April 2, 1993  
LD-93-058

Docket No. 52-002

Subject: System 80+<sup>TM</sup> Fire Protection and Revised DSER Responses

Figure 6.2-37 Pressure vs Time

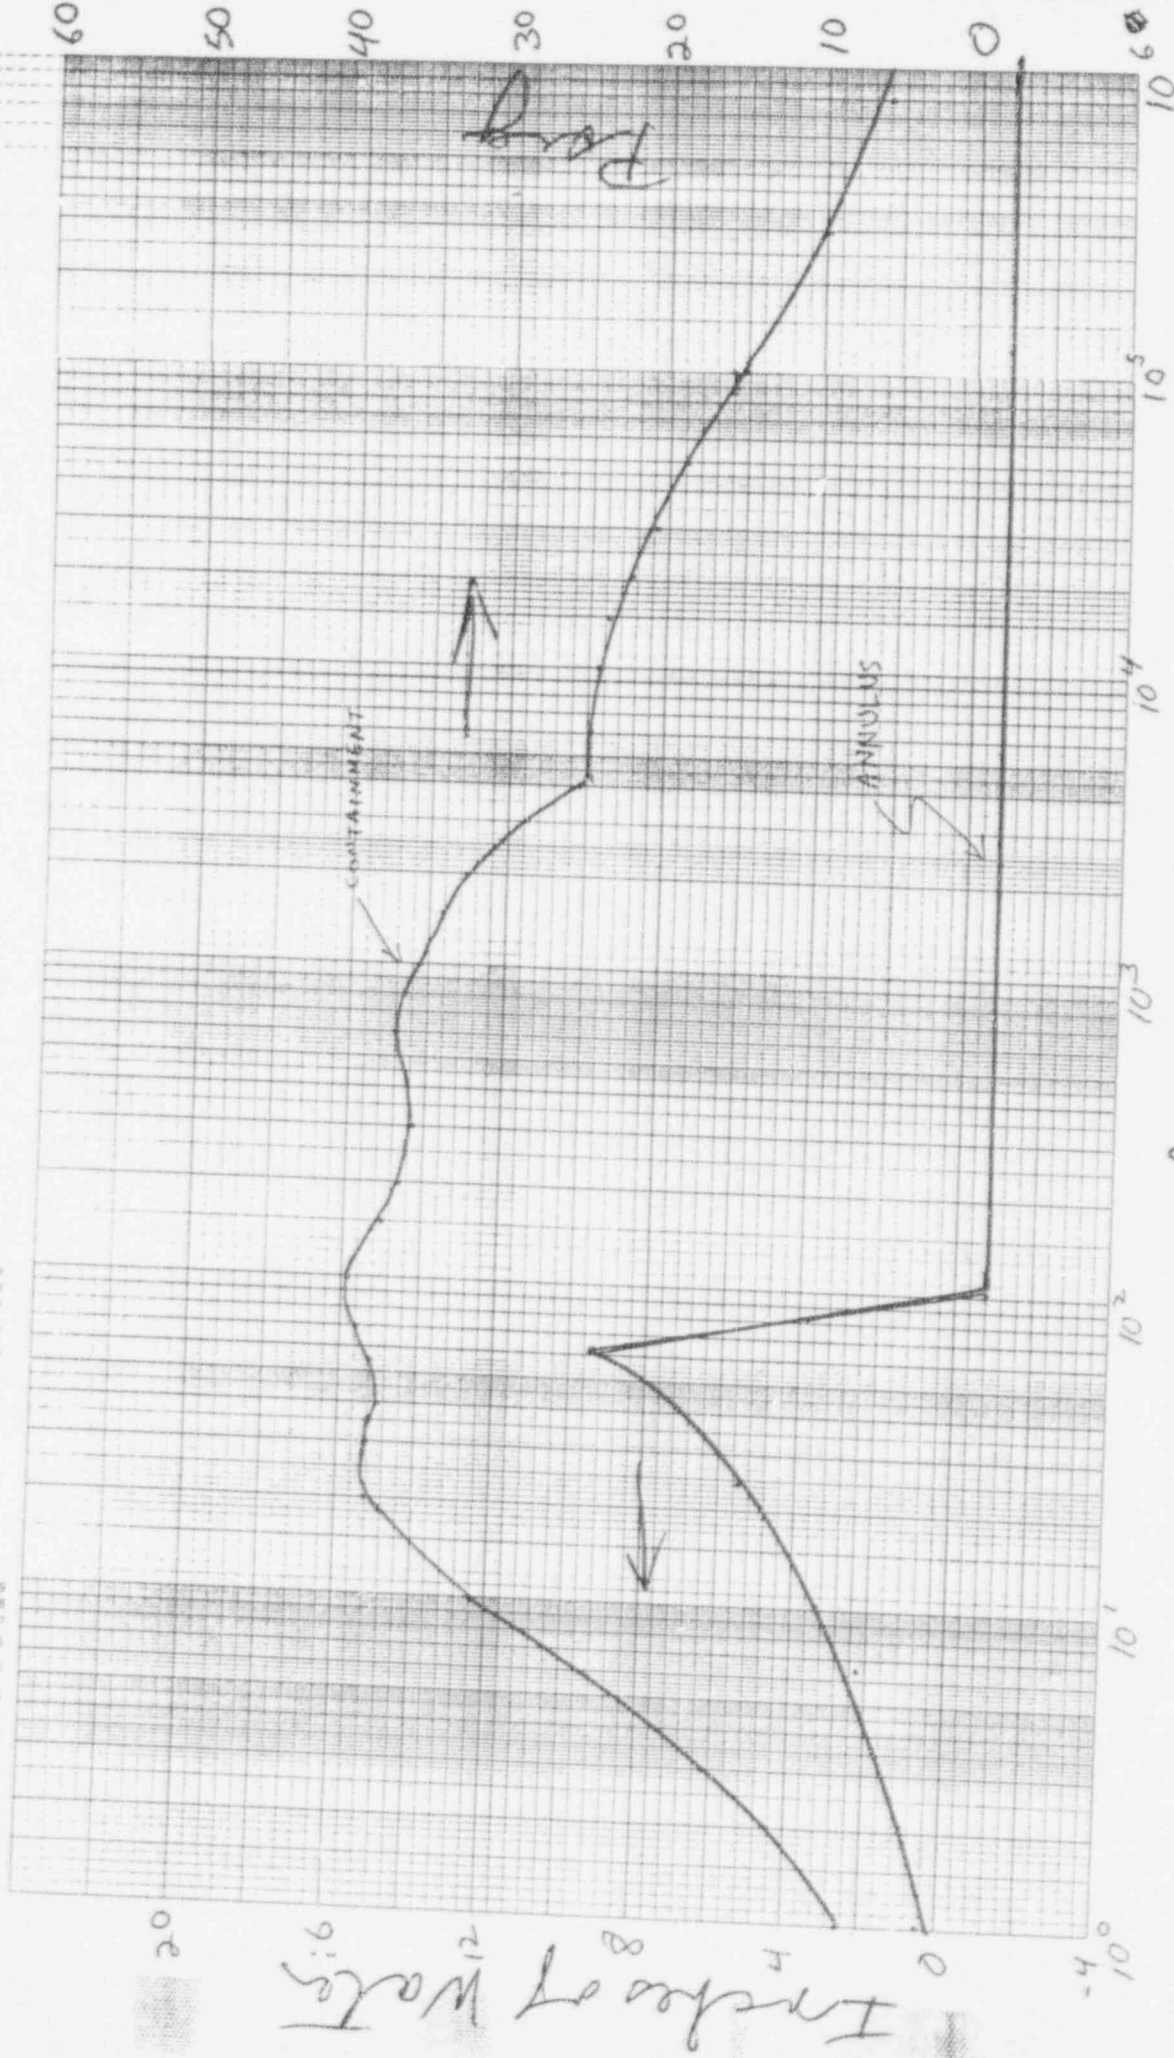
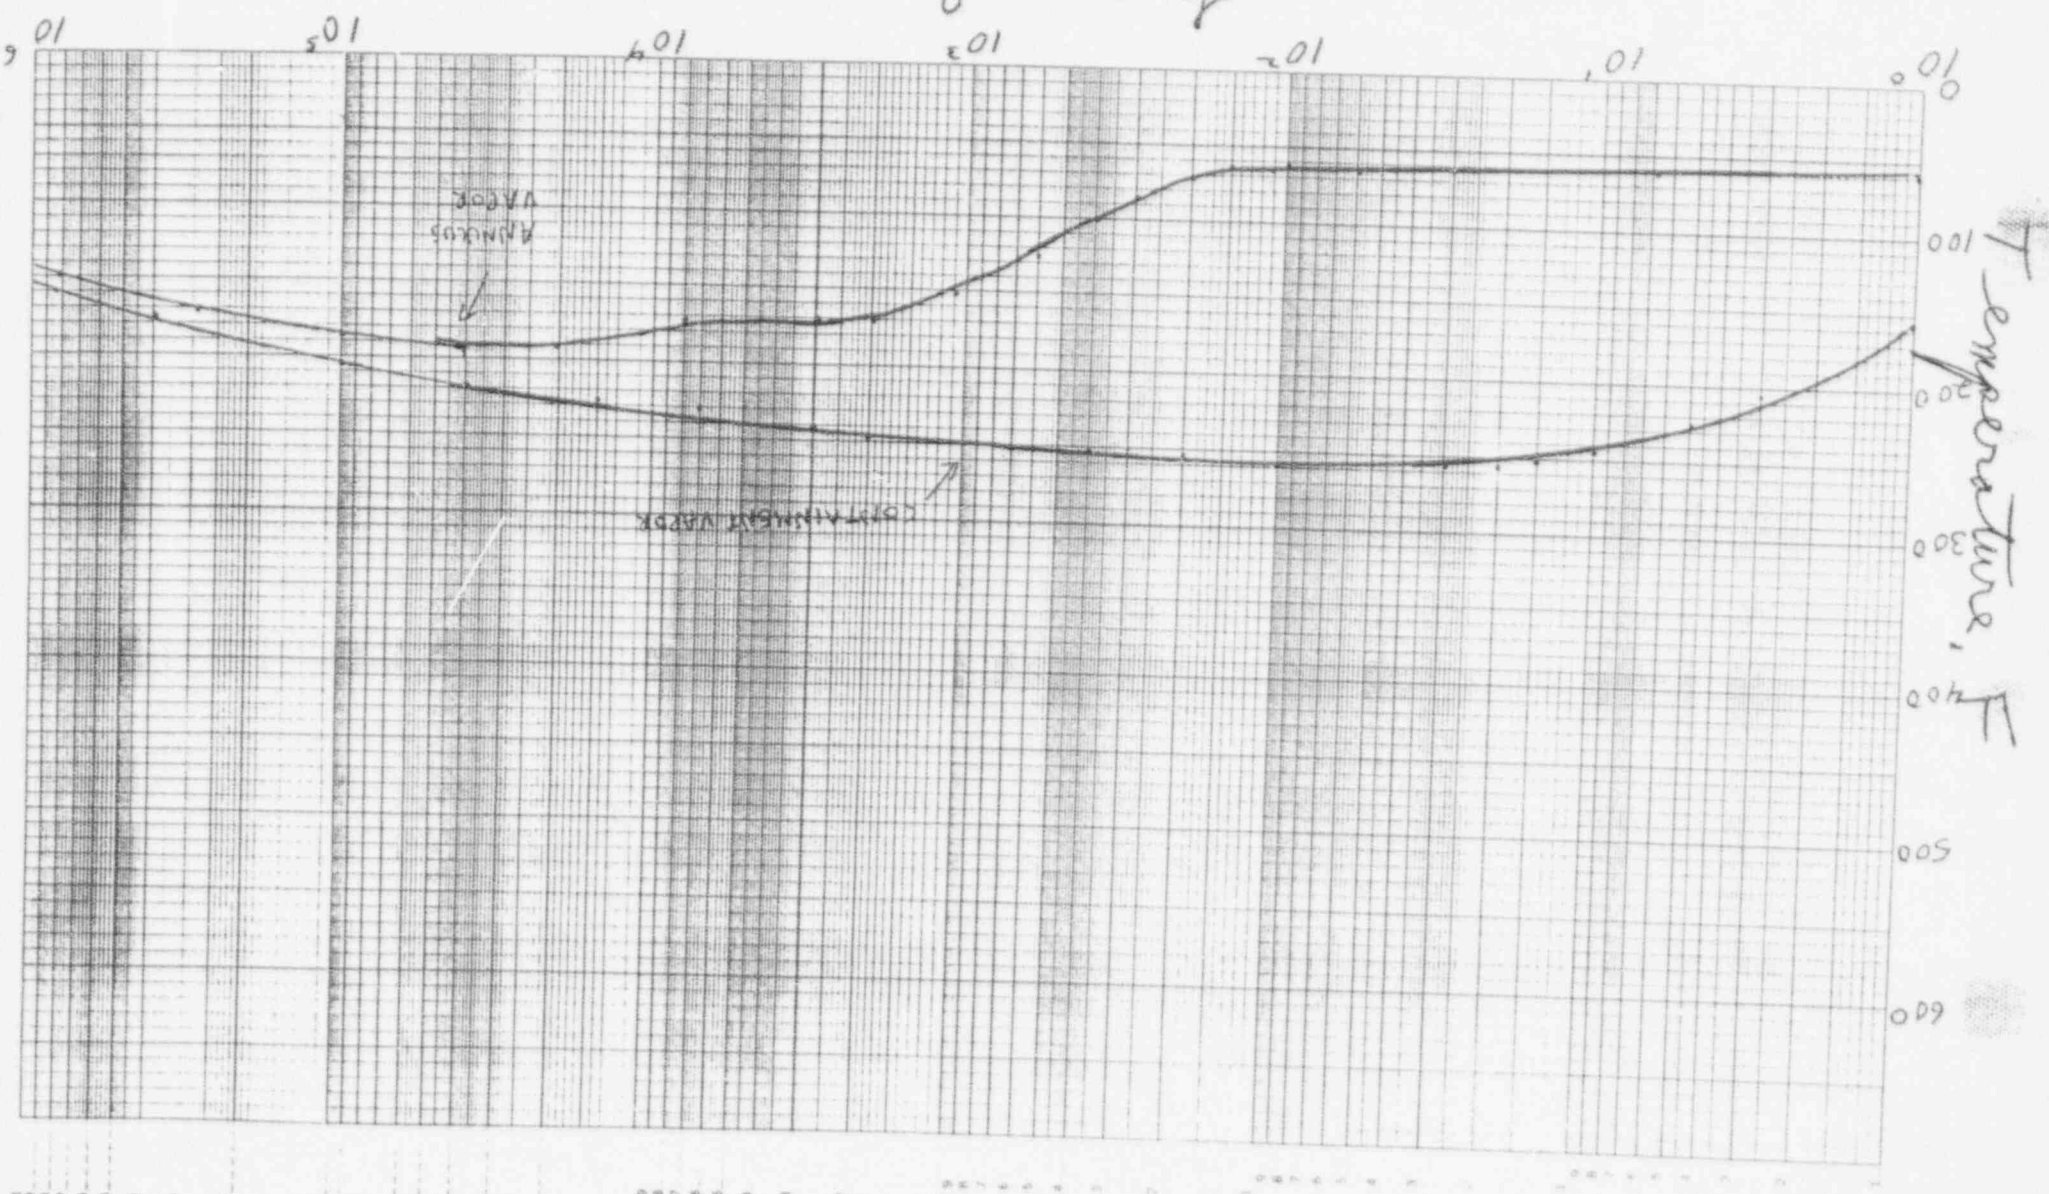
Attachment 2 provides a revision to open item 6.2.3-3 (SPLB) as a result of the increased power rating for System 80+. The results did not change significantly, and the corresponding revision to CESSAR-DC is being printed in Amendment N.

Figure 6.2.1-37 shows the annulus pressure and the corresponding containment vessel pressure versus time for the double-ended suction leg case. Figure 6.2.1-38 shows the annulus temperature and the corresponding containment temperature for this case. Figure 6.2.1-39 shows the exhaust rate of the Annulus Ventilation System corresponding to the annulus pressure shown in Figure 6.2.1-37. The annulus pressure reaches a peak of 8.80 inches of H<sub>2</sub>O at 65 seconds and is negative after 100 seconds. The temperature in the annulus reaches a peak of 160°F after 13,750 seconds. *104 9.30 63 195°F at 43000*

The analyses are based  
on a nominal core  
power of 3914 MWt.
